M E M O

Planning application 19/000053/CM

Land at Lea Castle Farm, Wolverley Road, Broadwaters, Kidderminster, Worcestershire

Request for clarification: ancient woodland protection measures and BNG evidence.

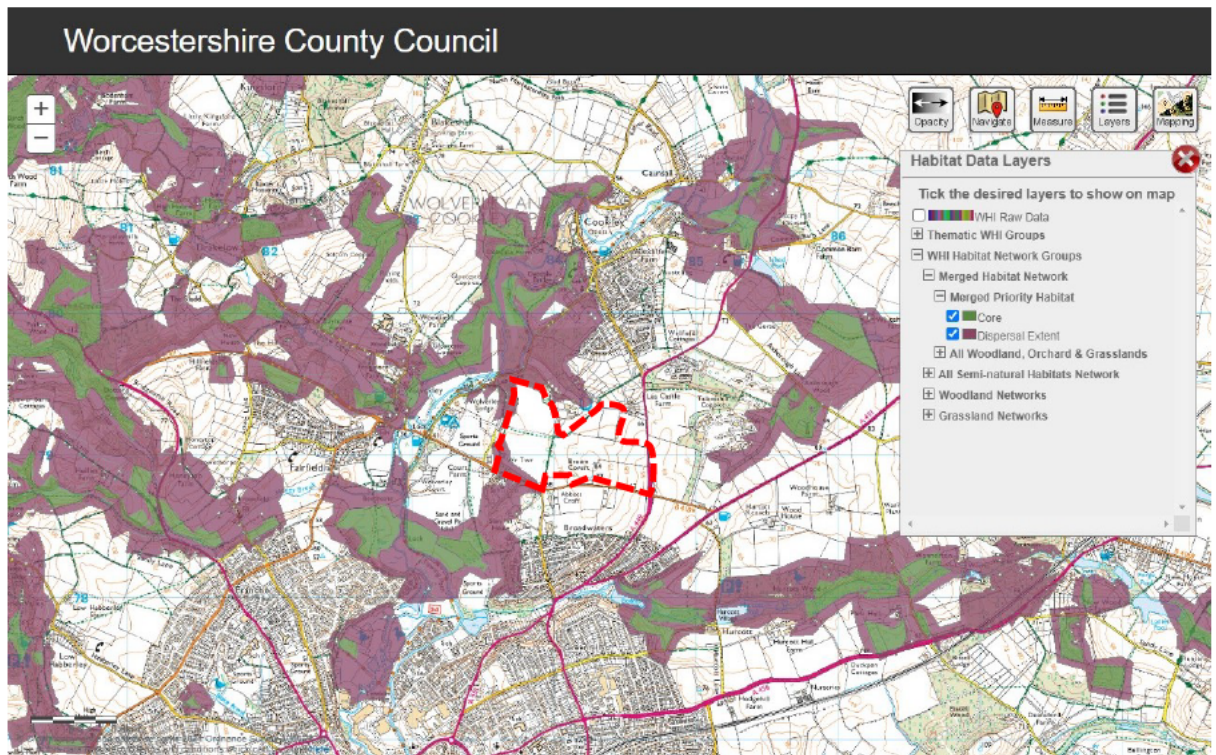
Focusing then on potential effects of fragmentation on dormouse, should they occur here, I have referenced the Worcestershire Habitat Inventory to see if a coherent habitat network exists in the locality which might be under pressure of deterioration from any disturbance effects. I include below an image of the combined priority habitat network although of greater relevance to dormice would be the woodland habitat network as broadleaved and particularly ancient woodlands are key habitats for dormice. In practicality there appears to be no significant difference between the woodland and combined priority habitat networks in this location. I'd highlight the 'core' areas of priority (habitats of principle conservation interest as listed at Schedule 40 of the Natural Environment and Rural Community Act (2006) illustrated below in green, and the 'dispersal extent' based on recorded movement

distances of generic and focal faunal species, calculated using 'least-cost' network analysis, as illustrated below in purple:

My interpretation of WHI mapping remains unchanged from my consultation response of November 2020: that *“effects of habitat severance, including built development and highway, are significant for dormouse, as this is a species with limited mobility and very specific habitat requirements... and I believe the lack of connectivity to other blocks of ancient woodland significantly reduces risk of dormouse dispersal to and occupation of woodland or hedgerow features...”*.

The site does not appear to contain any recognisably important habitat networks which of themselves would be a sensitive receptor for adverse impacts. A north-south habitat corridor abuts the western site boundary and, if it were not currently severed by the B4189 Wolverley Road (highways posing a significant barrier to movement of this ostensibly arboreal species), this corridor would abridge the woodland of the Staffordshire and Worcestershire Canal Local Wildlife Site with the various priority habitats of Puxton Marsh SSSI, located to the south-west of the site. However, this habitat corridor will be retained (and enhanced) through proposals. I consider any severance effects therefore unlikely to critically prevent dispersal of dormice (if present) across the local landscape, because the habitat network here is already significantly fragmented by highway and watercourses.
